ALL OPERATORS MESSAGE

Ref. AOM: 42/72/2016/11 issue 2

Aircraft models: ATR42 and ATR72

SUBJECT: Passenger door forward handrail quick release pin

Picture 1: forward handrail in deployed position

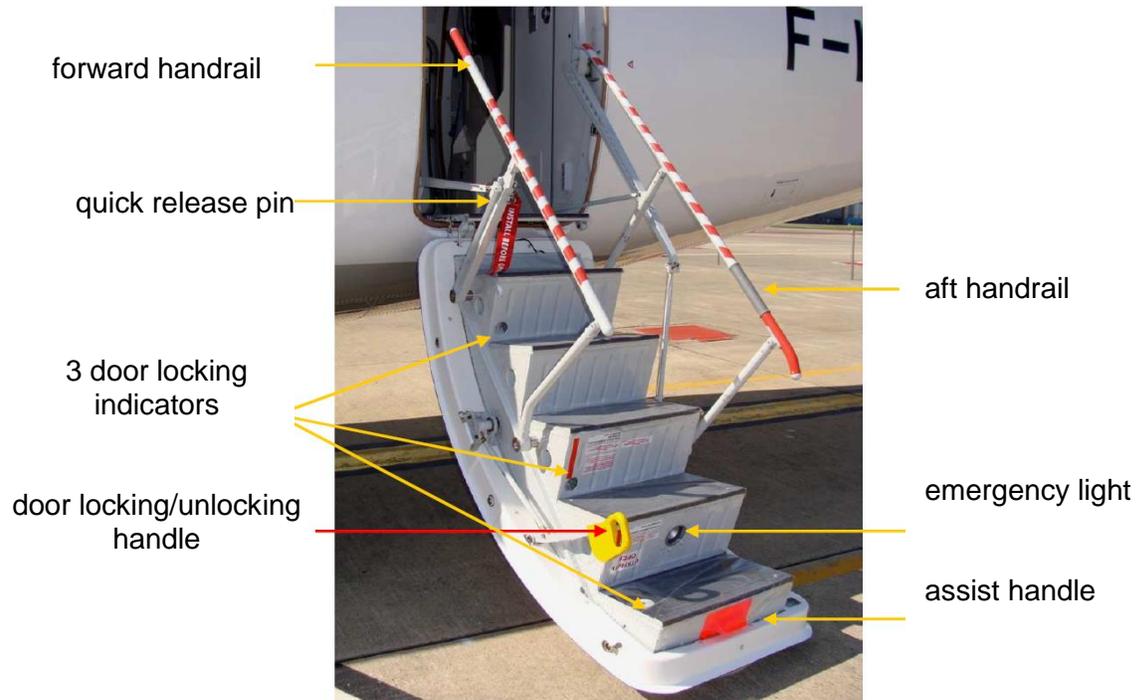
The passenger door located at the rear left-hand side of the aircraft is an outward opening type door. Attached to the integrated stair structure is an aft folding handrail which, by means of a linkage to the fuselage structure automatically deploys when the door is opened. On ATR aircraft having embodied specific modification (refer to effectivity paragraph), a second adjustable forward handrail deploys automatically when opening the door, providing that the quick release pin is in “ground” normal position (refer to Appendix 1 Picture 1).

Picture 2: forward handrail in folded position

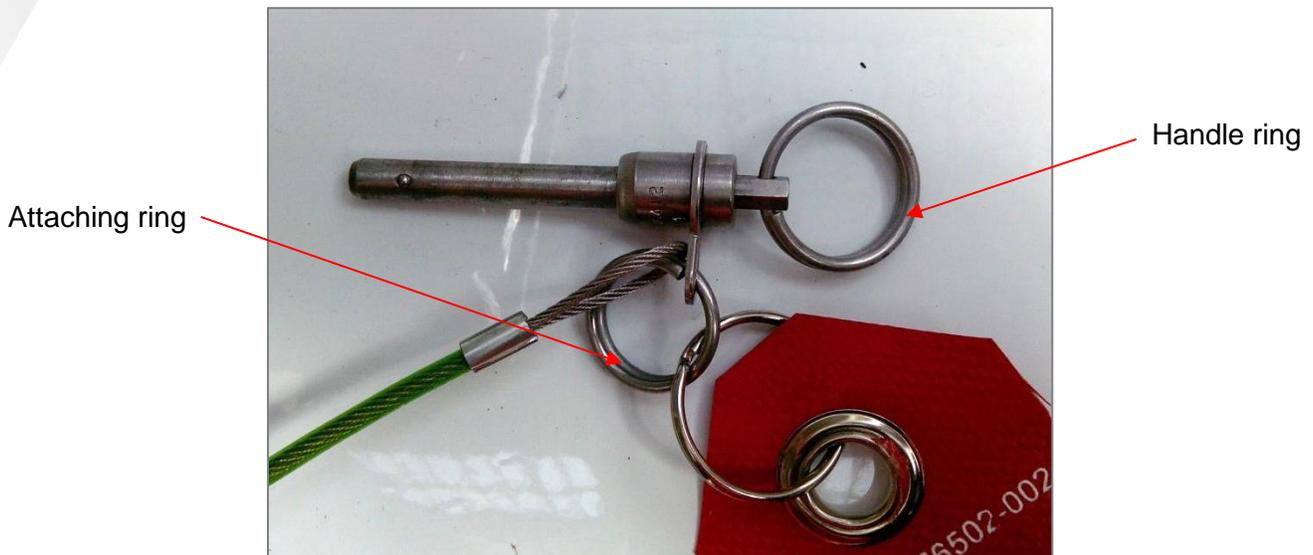
If the quick release pin fails to perform its intended function (or if it is not installed in “ground” position), the forward handrail will fall into its folded position (refer to Appendix 1 Picture 2).

Picture 3: current quick release pin P/N MS17990C412 and its warning streamer correct installation

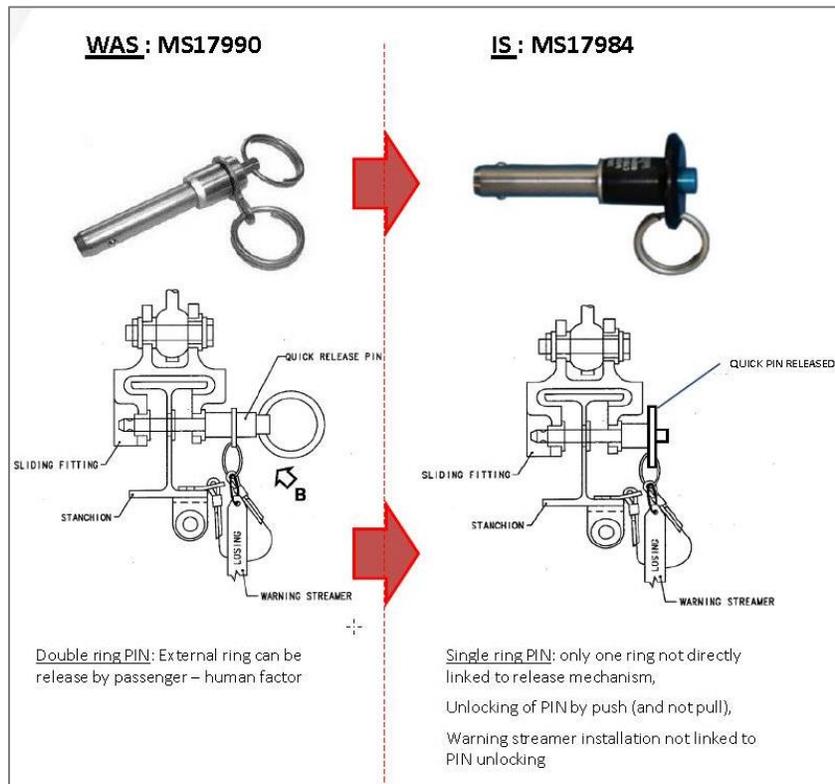
- 1) The operator to replace at the first opportunity, the current quick release pin P/N MS17990C412 by a new pin P/N MS17984C412.
- 2) The Operator crew members to make sure that the quick release pin is correctly locked,
- 3) The line maintenance staff to check that the quick release pin and red warning streamer are correctly installed. For the current quick release pin P/N MS17990C412, the red warning streamer has to be attached to the attaching ring and not to the handle ring (refer to Appendix 1 picture 3).

Picture 4: Current P/N MS17990C412 and New P/N MS17984C412 to be installed

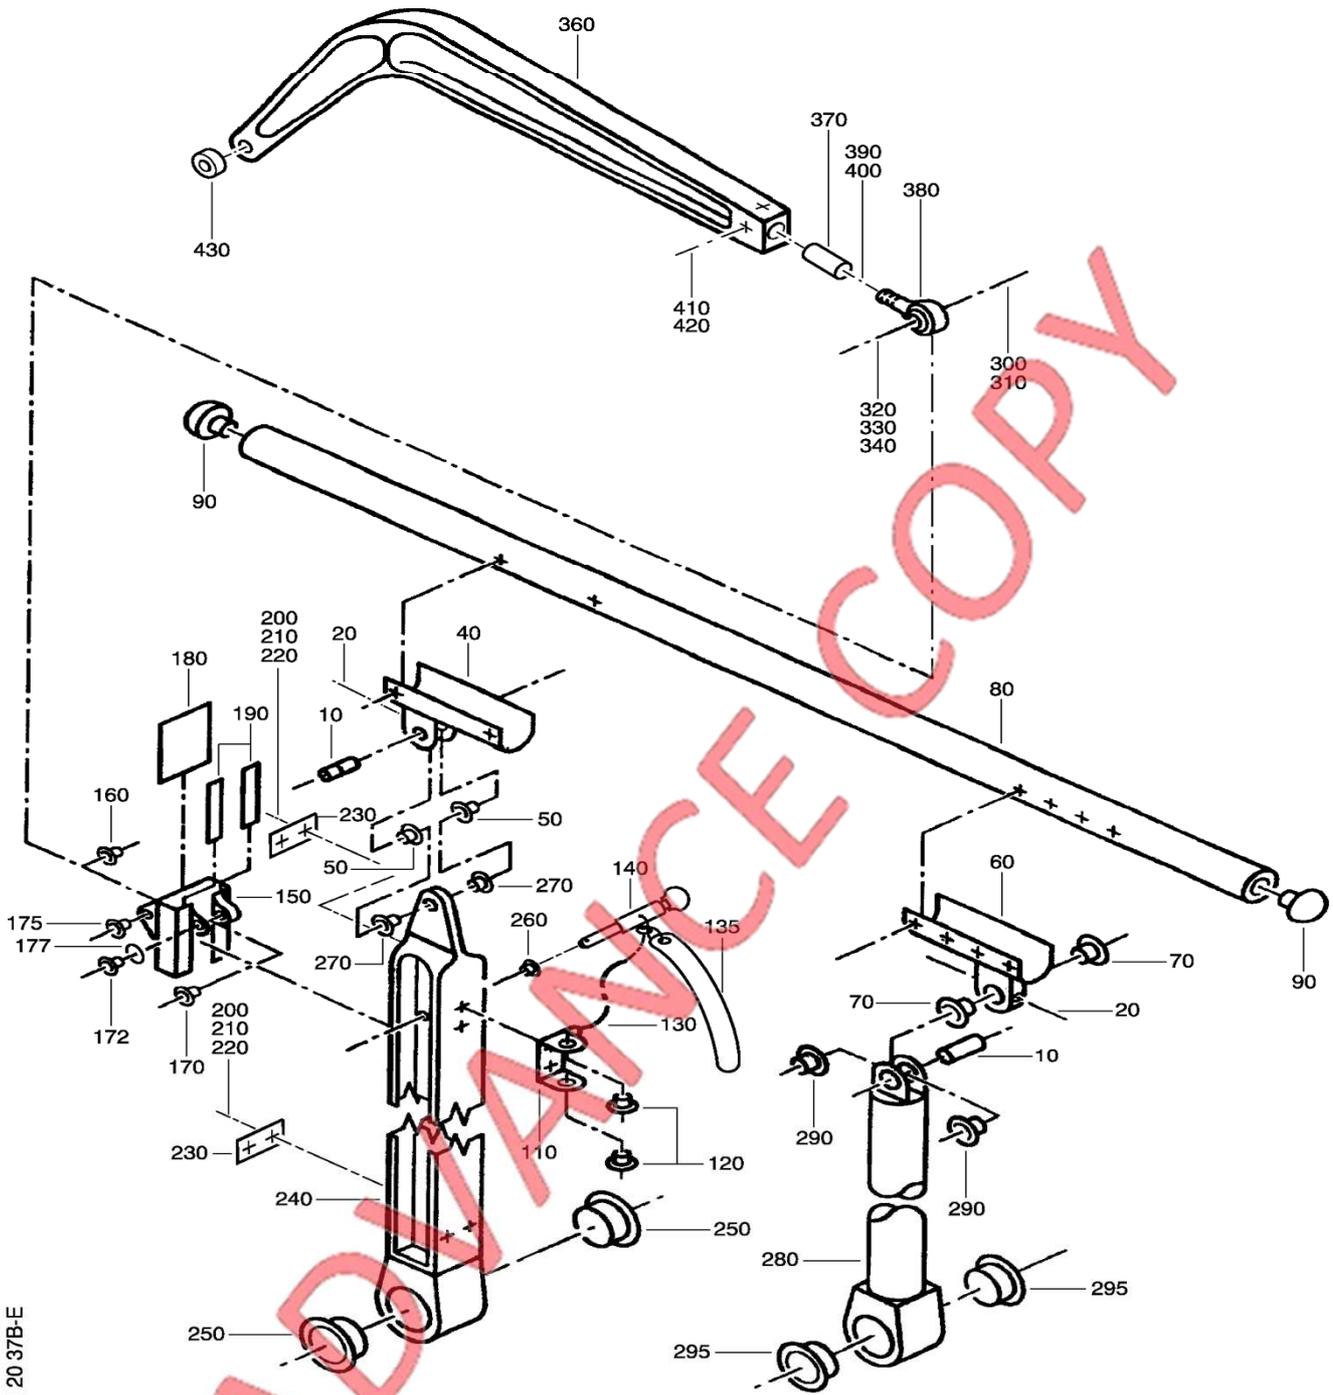
- Operator cabin crew members to follow the Cabin Crew Operating Manual procedure, to check that the quick release pin is in good condition, and to make sure that, while opening the door prior to each boarding or disembarkation, the quick release pin is correctly locked.
- Line maintenance staff to check that for the quick release pin MS17990C412 (Double ring), and the red warning streamer are correctly installed at the attaching ring and not at the handle ring (refer to Appendix 1 picture 3).
- Operator, to replace at the first opportunity, the current quick release pin P/N MS17990C412 by the new interchangeable one P/N MS17984C412 (refer to Appendix 1 picture 4).

- A quick release pin check and installation recommendation in the Cabin Crew Operating Manual revision RN03.
- A new quick release PIN: MS17984C412 to avoid accidental pin unlocking during boarding or disembarkation.

Figure 37B

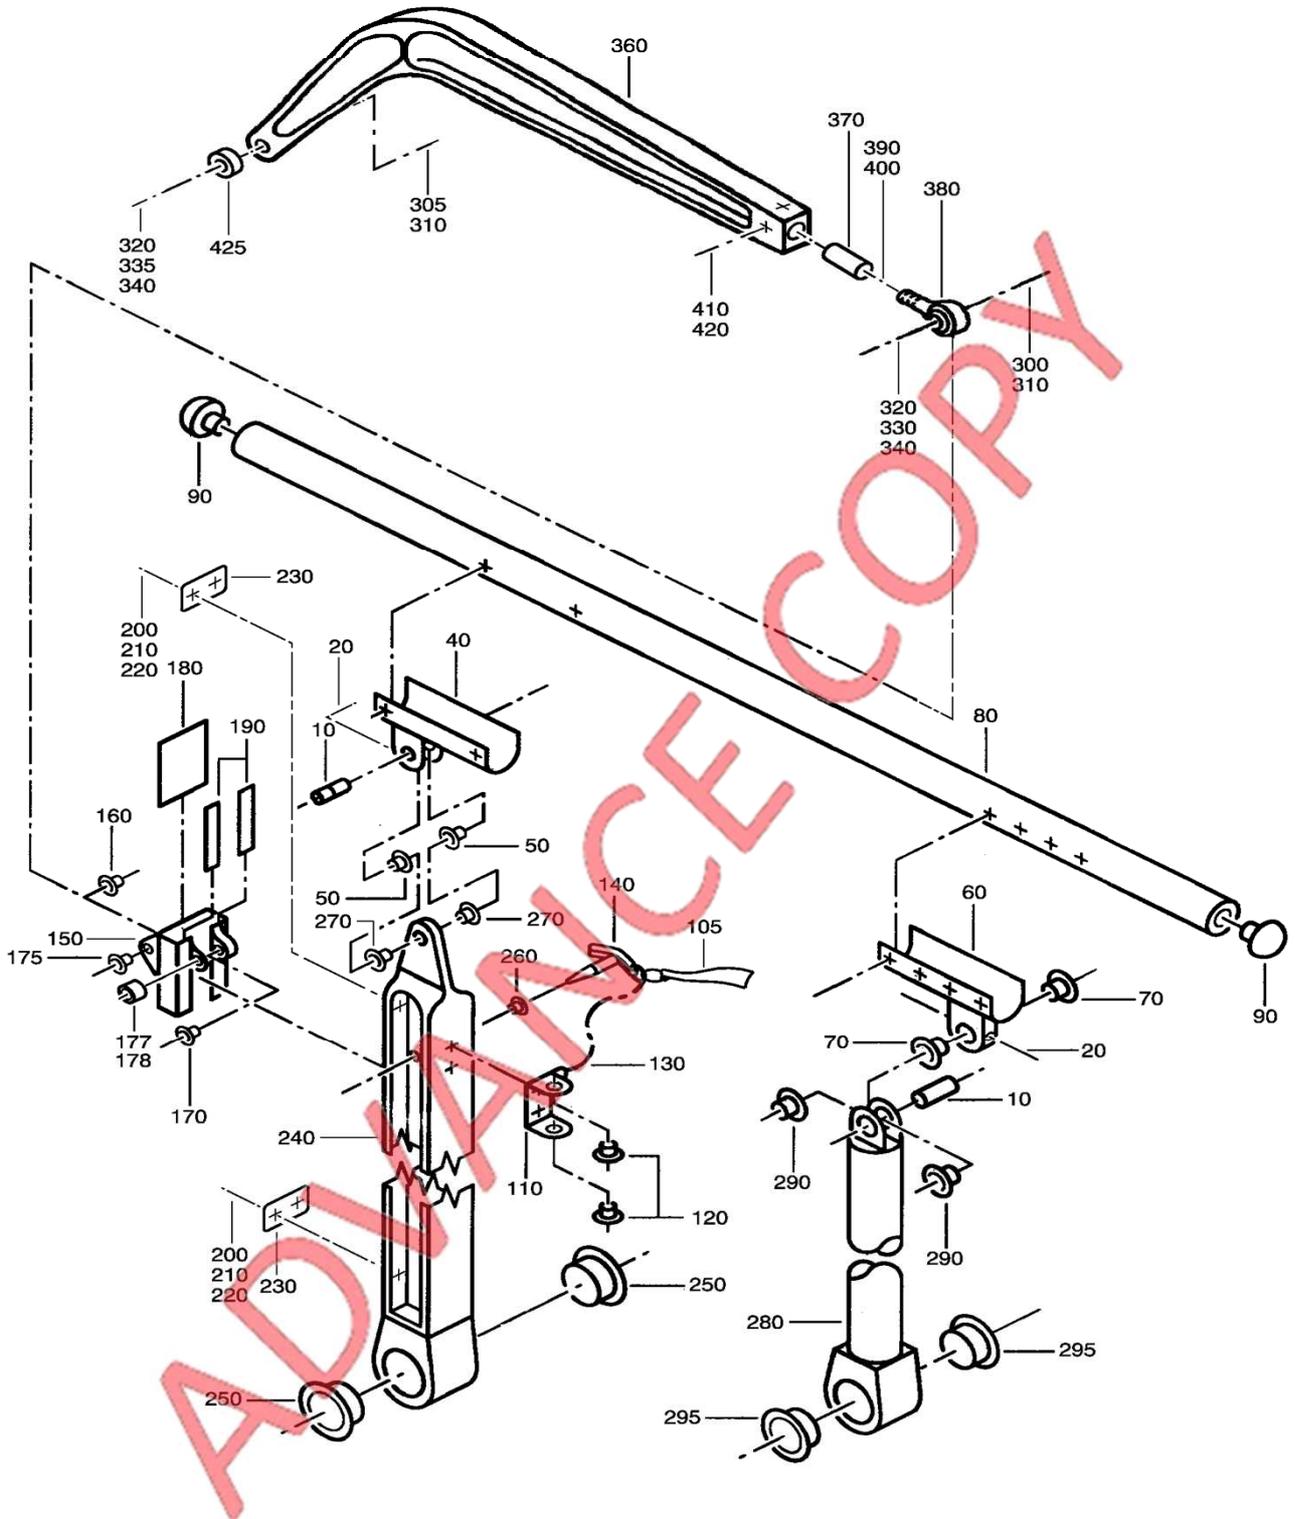
| FIG | ITEM | PART NUMBER | NOMENCLATURE | USAGE | QTY |
|-----|-------|-----------------|---|--------------------|-----|
| | 140 | MS17990C412 | ..PIN-QUICK RELEASE BUY PN MS17984C412 | V96906 | 001 |

Note: The new P/N MS17984C412 will appear at the next revision of your IPC documentation. Please find in appendix 2 of this document an example of IPC advanced copy. Dedicated advanced copy can be delivered upon request.

Figure 1

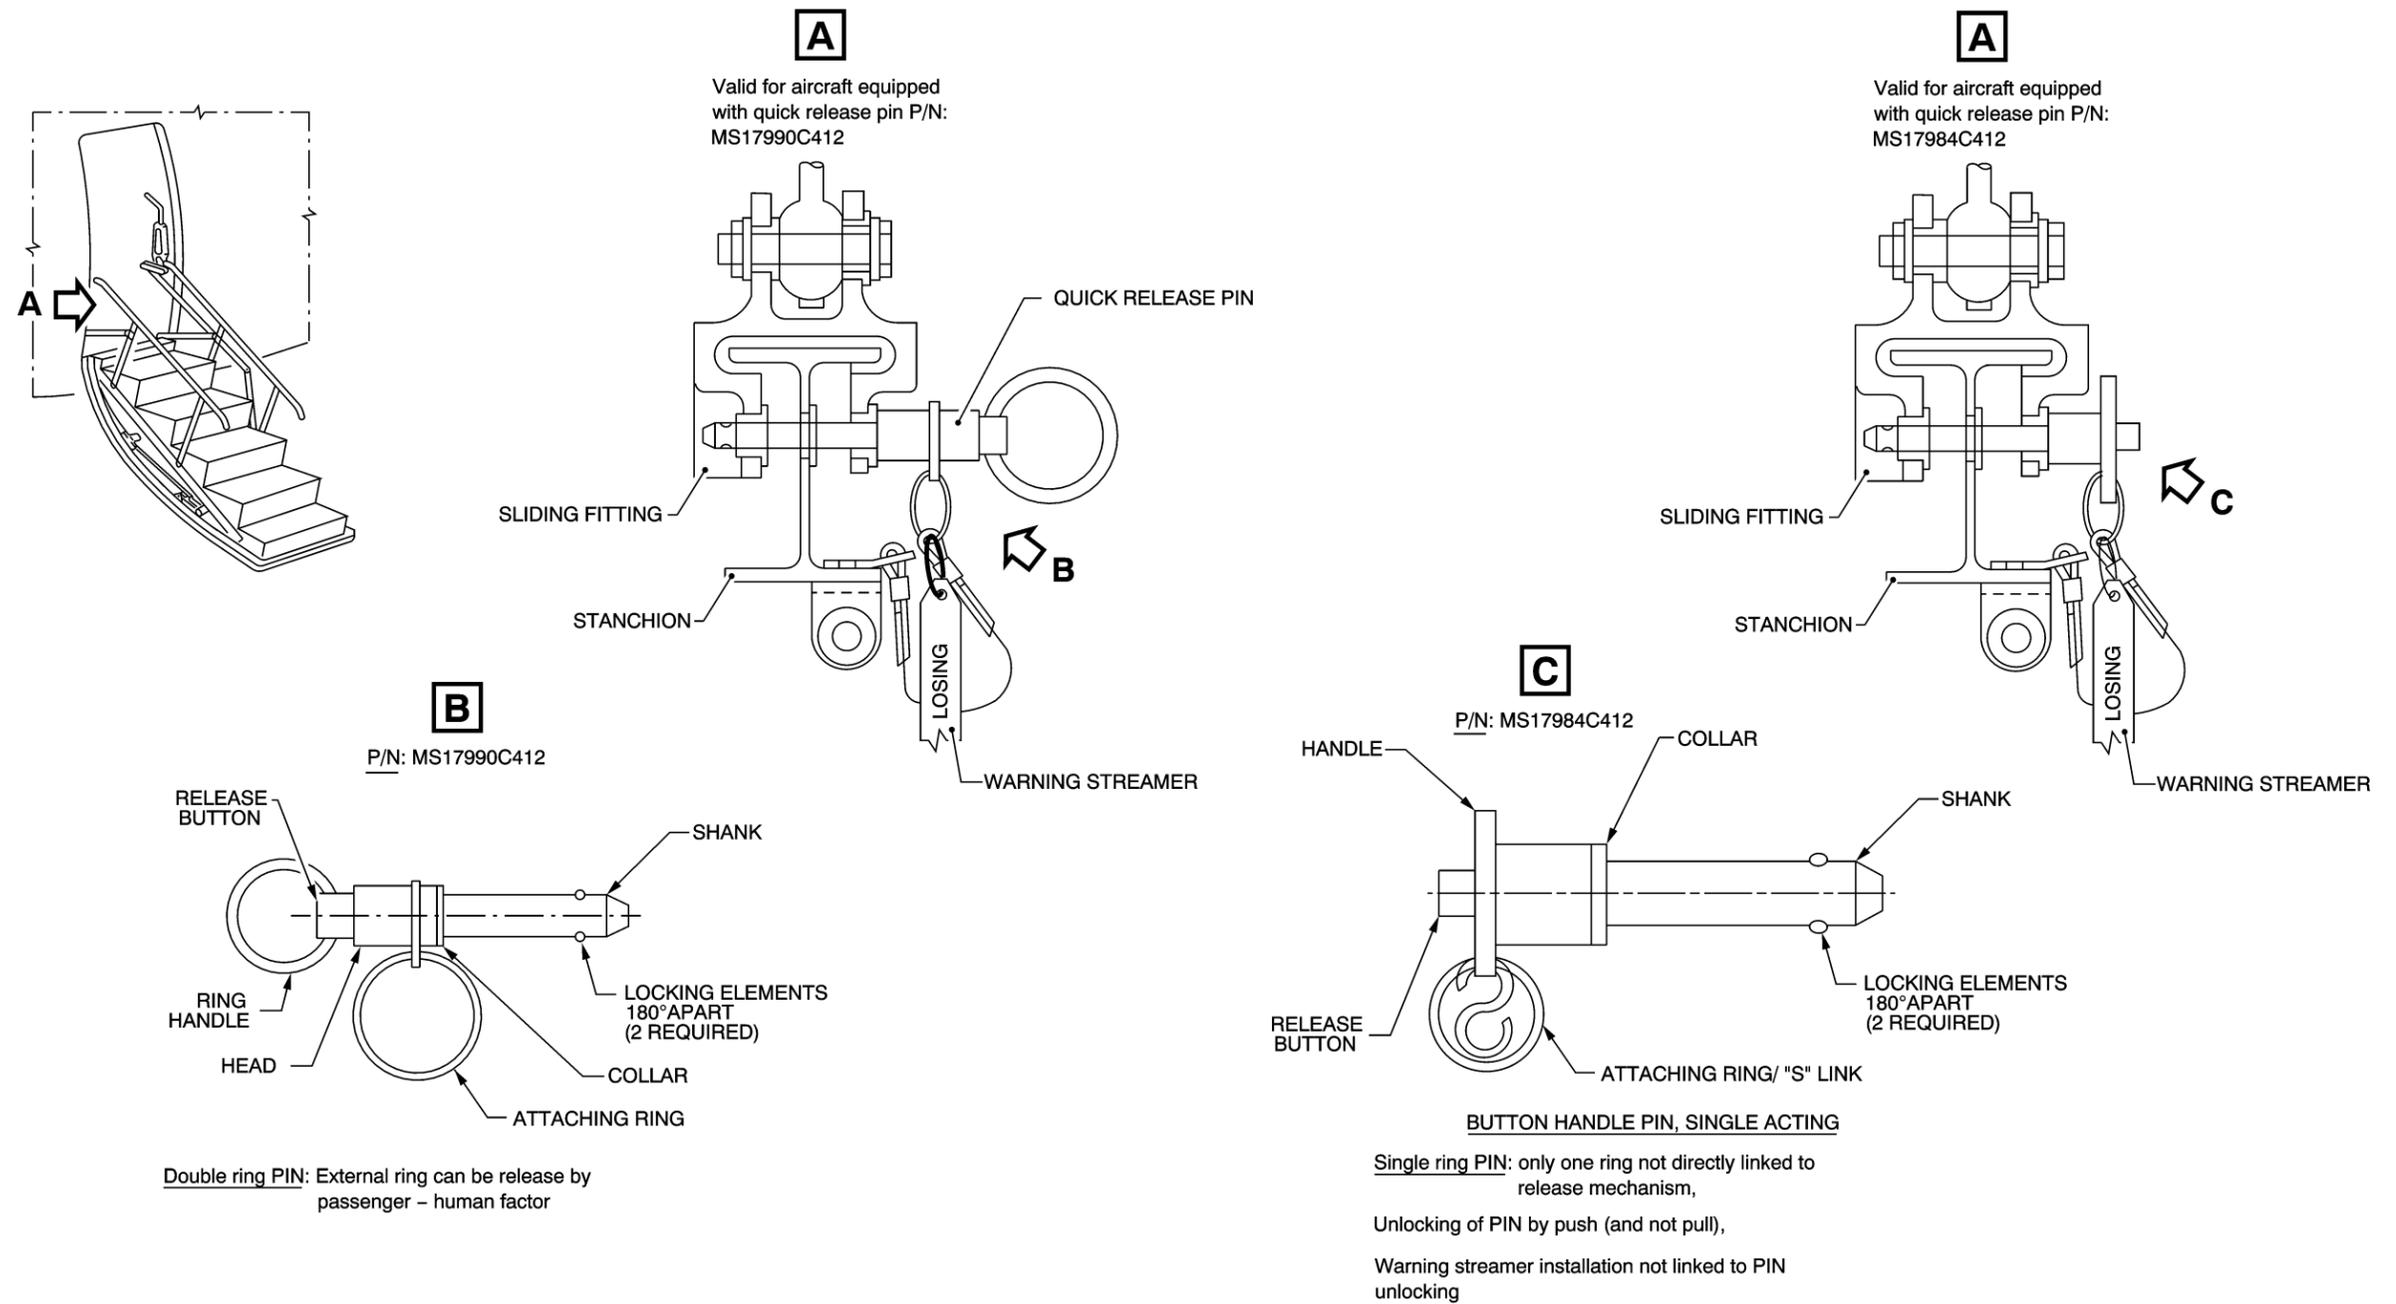
Also, the warning streamer, usually fixed to the attaching ring, was found incorrectly installed to the ring handle of pin P/N MS17990C412: in this case, if inadvertently the streamer is dragged away it can pull out the pin allowing the sliding fitting to move and the handrail to get free.

Operator maintenance staffs are also recommended to pay attention that, the quick release pin and/or warning streamer are correctly installed at attaching ring and not at ring handle specifically for pin P/N MS17990C412 as for new interchangeable pin P/N MS17984C412 warning streamer installation is not linked to pin unlocking (refer to AMM (JIC) 52-11-00 OAC 10000 and to figure 1 for clarification).
